Item Name: Crosstube Turning Detail

DART AEROSPACE LTD	Work Order:	84104
Description: Crosstube Assembly	Part Number:	D407-667-245
Inspection Dwg: D407-667-245 Rev: F		Page 1 of 1

DRAWING NO. D407-667-245	TITLE CROSSTUBE ASSY (407 HIGH AFT)	REV. F	DART AEROSPACE LTD ENGINEERING ORDER		D.E.O. NO. D407-667-245-F-1	SHEET NO. SHEET 1 OF 2	SCALE NTS
DRAWN <i>[Signature]</i>	CHECKED <i>[Signature]</i>	MFG. APPR. <i>[Signature]</i>	APPROVED <i>[Signature]</i>		DE APPR. <i>[Signature]</i>		
DATE 11.04.08	DATE 11.04.12	DATE 11.04.12	DATE 11.04.12		DATE 11.04.12

DRAWING NO. D407-667-245	TITLE CROSSTUBE ASS'Y (407 HIGH AFT)	REV. F	DART AEROSPACE LTD ENGINEERING ORDER		D.E.O. NO. D407-667-245-F-2	SHEET NO. SHEET 1 OF 1	SCALE NTS
DRAWN 90	CHECKED AS	MFG. APPR. E	APPROVED MP		DE APPR. H		
DATE 11.09.07	DATE 11.09.19	DATE 11.09.19	DATE 11.09.19		DATE 11.09.19

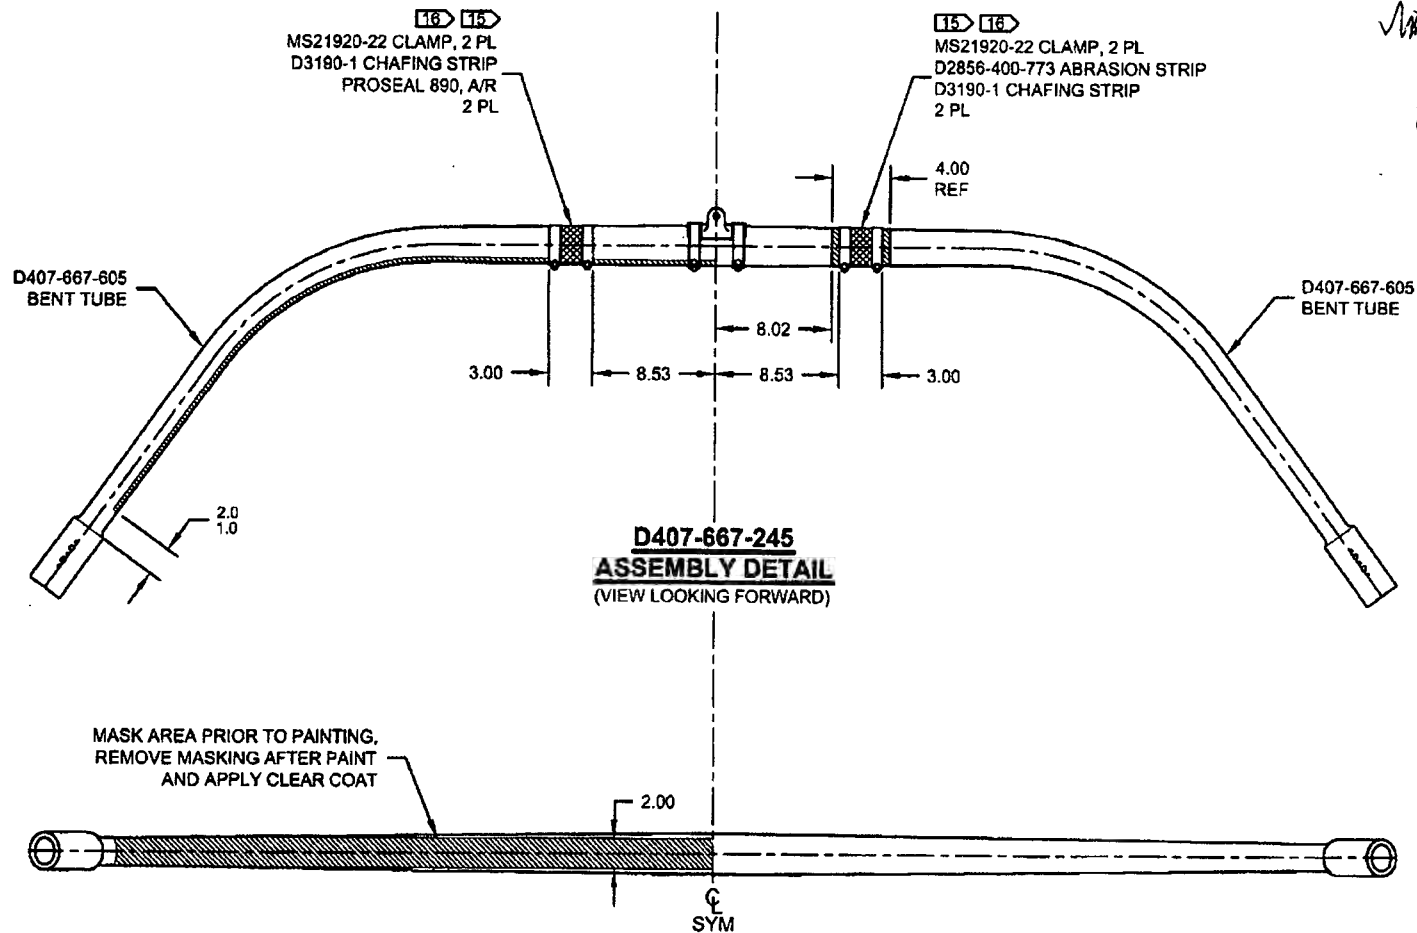
PURPOSE:

REMOVED ABRASION STRIP IN FAVOR OF A THIN LAYER OF PROSEAL 890.

NOTES 2 AND 15, SHEET 1 ARE AMENDED AS FOLLOWS:

- 2) FINISH: CHEMICAL CONVERSION COAT PER DART QSI 005 4.1
PRIME INSIDE AND OUTSIDE PER DART QSI 005 4.2
MASK UNDERSIDE OF CROSSTUBE AS SHOWN (HATCHED AREA) AND
PAINT OUTSIDE PER DART QSI 005 4.2
REMOVE MASKING AND APPLY CLEAR COAT
- 15) APPLY A THIN COAT OF PROSEAL 890 ON INSIDE CONCAVE SURFACE OF D3190-1
CHAFING SHIELDS AND LET CURE PER MANUFACTURER'S INSTRUCTIONS. INSTALL
PROSEALED D3190-1 CHAFING SHIELDS ONTO CROSSTUBE BY APPLYING A THIN COAT
OF PROSEAL 890 ONTO CROSSTUBE. BE SURE TO ELIMINATE ANY AIR GAPS.

- 2) FINISH: CHEMICAL CONVERSION COAT PER DART QSI 005 4.1
PRIME INSIDE AND OUTSIDE PER DART QSI 005 4.2
PAINT OUTSIDE PER DART QSI 005 4.2
- 15) INSTALL D2856-400-773 ABRASION STRIP WITH A 0.13 REF GAP ON BOTTOM SIDE OF
CROSSTUBE PER QSI 035.
